Model: <b>ARDF (DF3060)</b>	Date: 12-Sep-11	No.: RD578001
-----------------------------	-----------------	---------------

Subject: Firmware Release Note: ARDF (DF3060)		Prepared by: T. Nihei	
From: 1st Overseas Tech Support Sec., 1st PQM Dept.			
Classification:	<input type="checkbox"/> Troubleshooting	<input type="checkbox"/> Part information	<input type="checkbox"/> Action required
	<input type="checkbox"/> Mechanical	<input type="checkbox"/> Electrical	<input type="checkbox"/> Service manual revision
	<input type="checkbox"/> Paper path	<input type="checkbox"/> Transmit/receive	<input type="checkbox"/> Retrofit information
	<input type="checkbox"/> Product Safety	<input checked="" type="checkbox"/> Other (Firmware)	<input checked="" type="checkbox"/> Tier 2

Model: ARDF (DF3060)		Date: 17-Feb-12	No.: RD578002
Subject: Parts Catalog Correction (Decal)		Prepared by: T. Nihei	
From: 2nd Tech Service Sect., MFP/P Tech Service Dept.			
Classification:	<input type="checkbox"/> Troubleshooting <input checked="" type="checkbox"/> Part information <input type="checkbox"/> Action required <input type="checkbox"/> Mechanical <input type="checkbox"/> Electrical <input type="checkbox"/> Ser

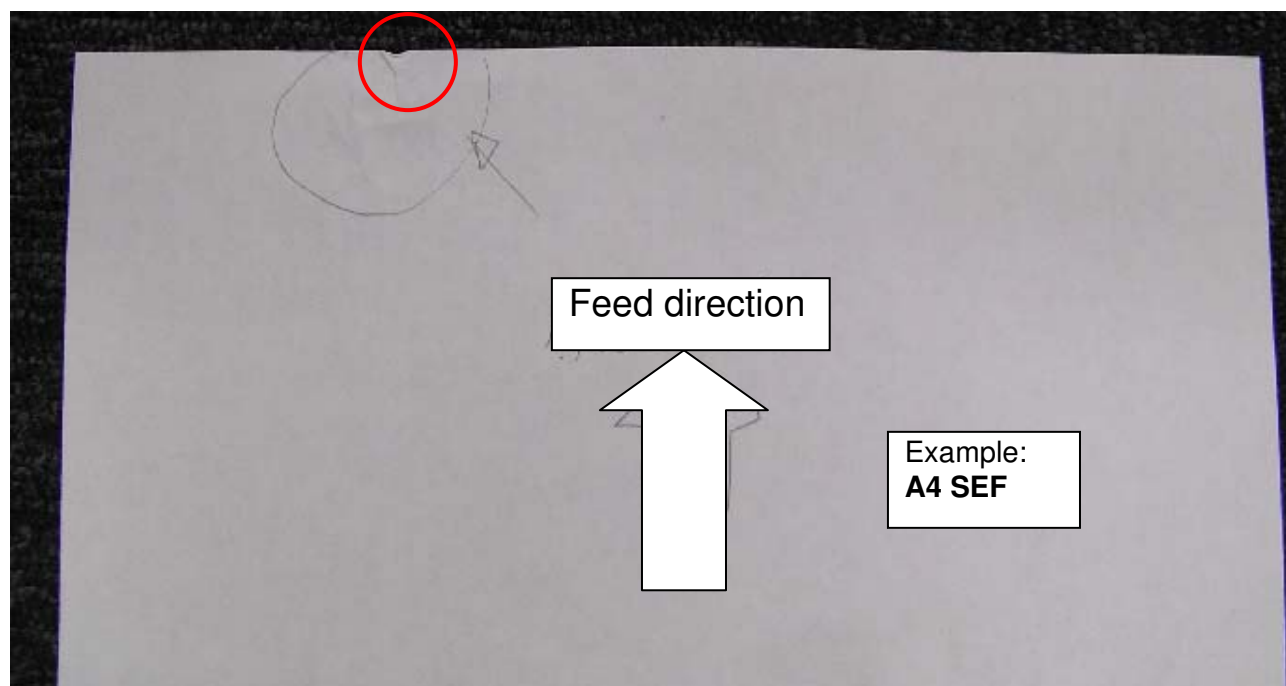
Old part number	New part number	Description	Q'ty	Int	Page	Index	Note
D5786011	D5786012	DECAL:MISFEED REMOVAL	1-1	X/X	5 17	1 4	Set as X/O
D5786061	D5786062	DECAL::ORIGINAL:MANY LANGUAGES	1-1	X/X	5 17	43 3

**Change:** The illustrations on these decals were changed.

**Reason:** To further increase usability.

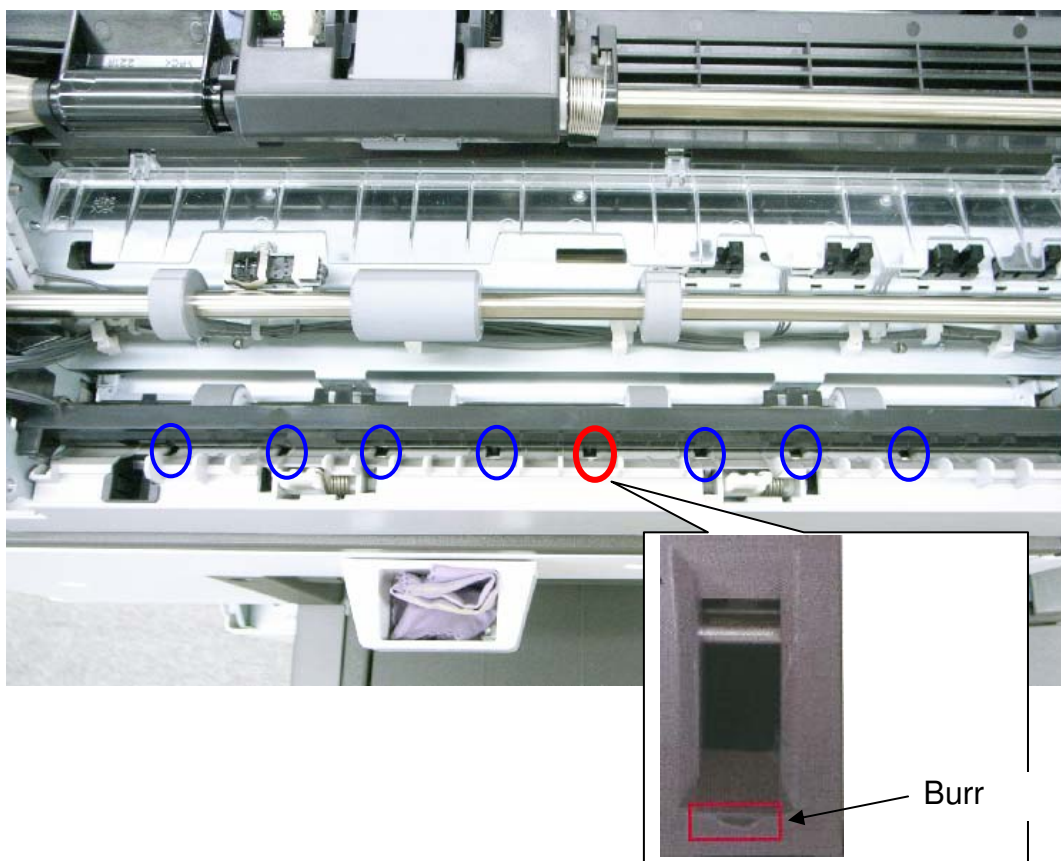
One of the holes in the ARDF base frame (see the photograph in Step 4 below) has a small burr, and the leading edge of the original may catch on this burr.

**Note:** After you remove the guide plate, you will see the eight holes circled in the photograph below (looking from the left side of the machine). The hole with the burr is the 4<sup>th</sup> from the right, circled in red below.

Remove the burr.

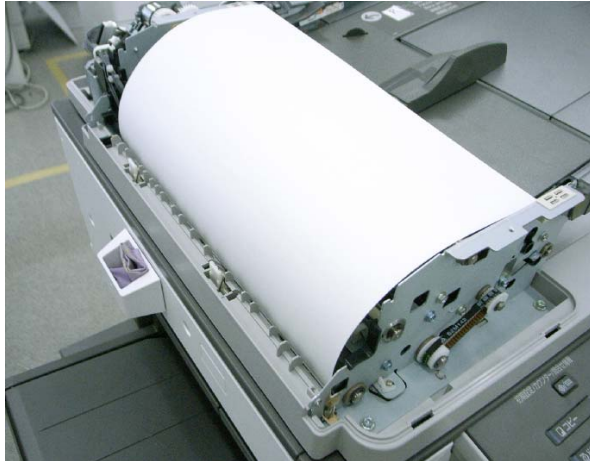
5. Insert a sheet of paper between the ARDF base frame and the entrance guide plate, as shown in the photograph below.

6. Remove the burr.
7. Reattach all the parts that you removed in the steps above.
8. Open the ARDF and clean the ARDF exposure glass.

**Note:** This is because some of the shavings from the burr may have dropped onto the exposure glass when you removed the burr in Step 6.

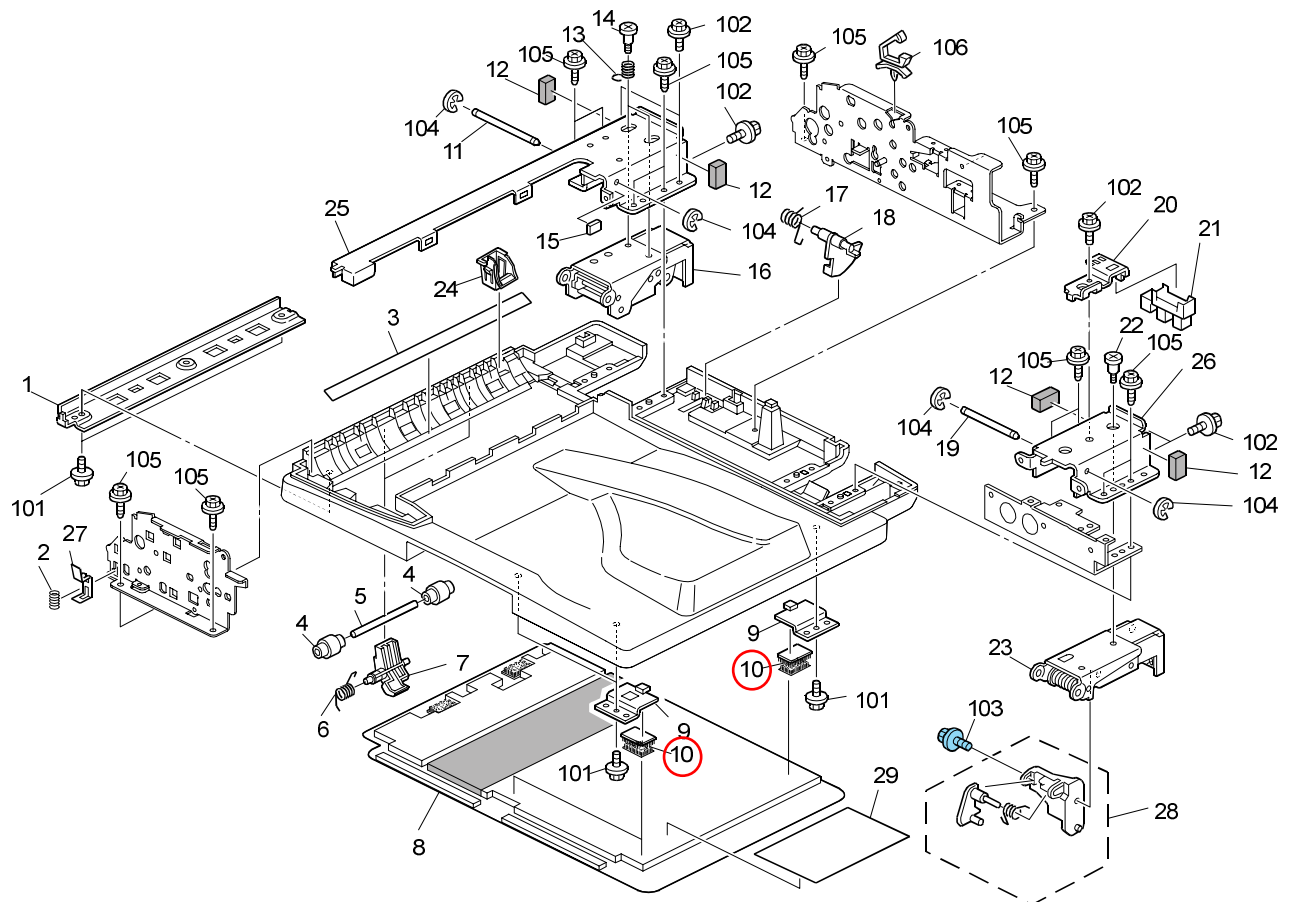
Part number	Description	Q'ty	Int	Page	Index	Note
B3514322	TAPE - PLATEN SHEET	3	-	15	10

**Change/Reason:** The illustration was corrected.

- The Velcro (TAPE – PLATEN SHEET) is not included in the Pressure Plate Assembly service part (Index 8).
